Subject: RESPONSE TO CITY OF AGOURA HILLS – GEOTECHNICAL REVIEW SHEET
29505 AND 29515 AGOURA ROAD
AGOURA HILLS, CALIFORNIA

Date: February 29, 2016
GDI #: 15.00103.0203**CITY OF AGOURA HILLS - GEOTECHNICAL REVIEW SHEET**

CITY OF AGOURA HILLS - GEOTECHNICAL REVIEW SHEET

SITE PLAN

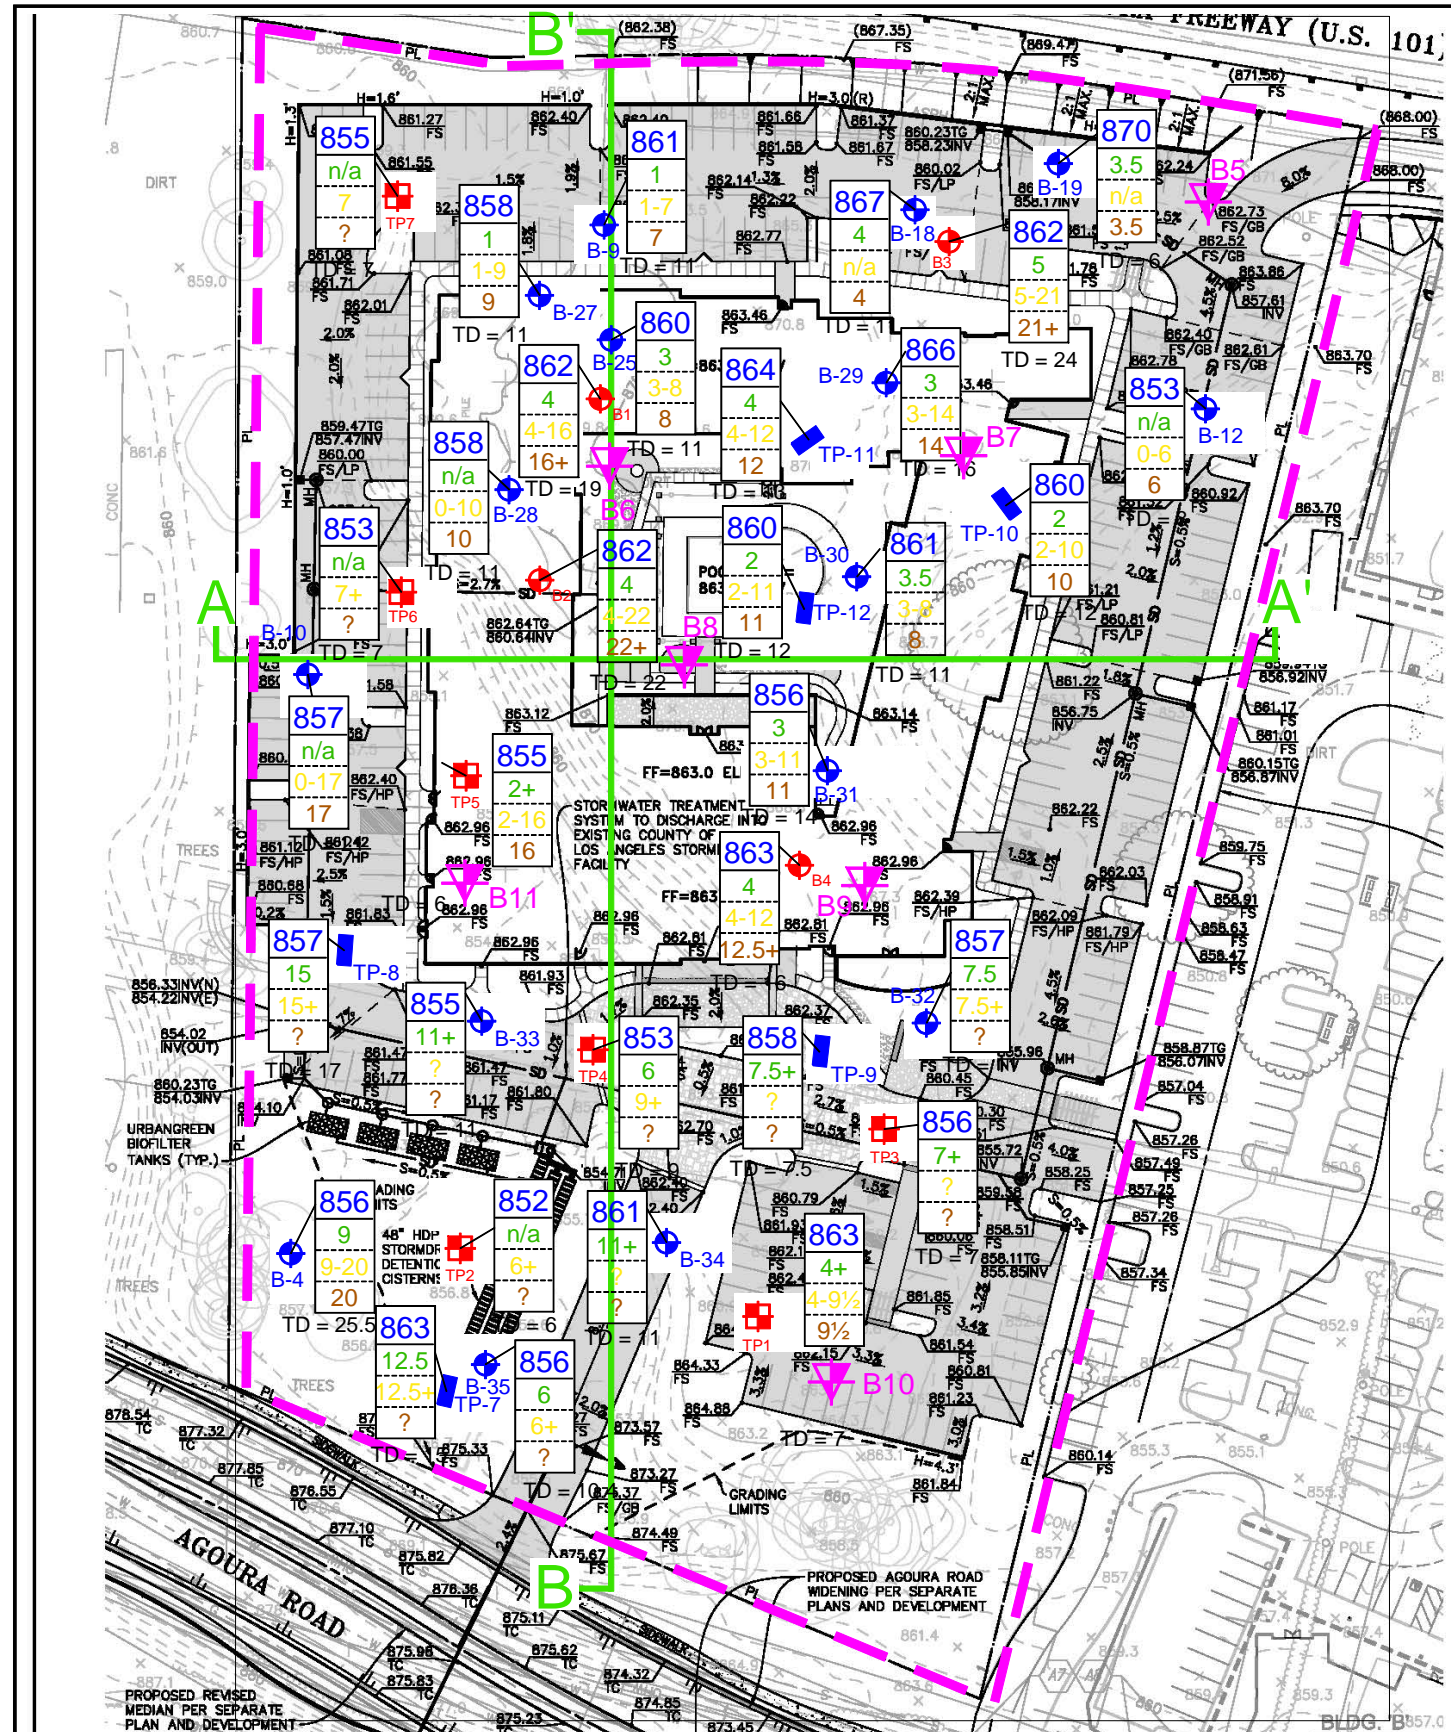
2. The site is underlain by up to 19 ft of surficial material including uncertified fill, topsoil and colluvium, alluvial deposits, and terrace deposits. Some of the underlying alluvium is wet and loose. The previous consultant recommended removal to bedrock. Geocon recommends removal to at least 5 ft below existing grade (and possibly deeper as determined in the field). Hence, a significant change is made in the recommended mitigation measures between the previous and current geotechnical consultant. With that being the case, and considering that substantial subsurface data is available, the consultant should further delineate and substantiate the recommended depth of overexcavation, particularly within settlement-sensitive structures.

Note 1: The report should provide adequate characterization of the geotechnical conditions at the site and provide preliminary geotechnical recommendations for mitigation measures (overexcavation). We understand and appreciate the consultant’s intent to verify these recommendations in the field during grading. However, based on available subsurface data, there are several points of exploration that indicate a likely need for deeper removals and should be considered and accounted for in the preliminary recommendations. Some examples:

As requested in the comment above, the consultant should further delineate the vertical and horizontal extent of the recommended removal and recompaction at the site.

The attached site plan (see Figure 1) was revised to better define the contact between the uncertified fill, top soil and colluvium, alluvial deposits, terrace deposits, and bedrock. Also, Geologic Cross Sections A and B (see Figure 2) have been updated to illustrate the contact between the uncertified fill, top soil and colluvium, alluvial deposits, terrace deposits, bedrock, as well as the proposed grading excavation bottom of 10 feet below proposed finished grade.

As a minimum, it is recommended that the upper 10 feet of existing earth material from proposed finished grade within the proposed building footprint area (see Site Plan, Figure 1) be excavated and properly compacted for foundation and slab support. All fill and backfill soils should be placed in horizontal loose layers approximately 6 to 8 inches thick, moisture conditioned to 2 percent above optimum moisture content, and properly compacted to a minimum 92 percent of the maximum dry density in accordance with ASTM D 1557 (latest edition). The contractor should be prepared for deeper excavations, as necessary, to remove any encountered fill or soft alluvial soils at the direction of the Geotechnical Engineer (a representative of Geocon West, Inc.). All foundations should be underlain by at least 8 feet of newly placed engineered fill and the grading contractor should verify proposed foundation depths prior to commencement of grading activities to ensure that the minimum 8-foot requirement is maintained. The excavation should extend laterally a minimum of 10 feet beyond the proposed building footprint area, including building appurtenances, or a distance equal to the depth of fill below the foundations, whichever is greater. The required over-excavation limits will be verified by the Geocon representative during site grading activities.
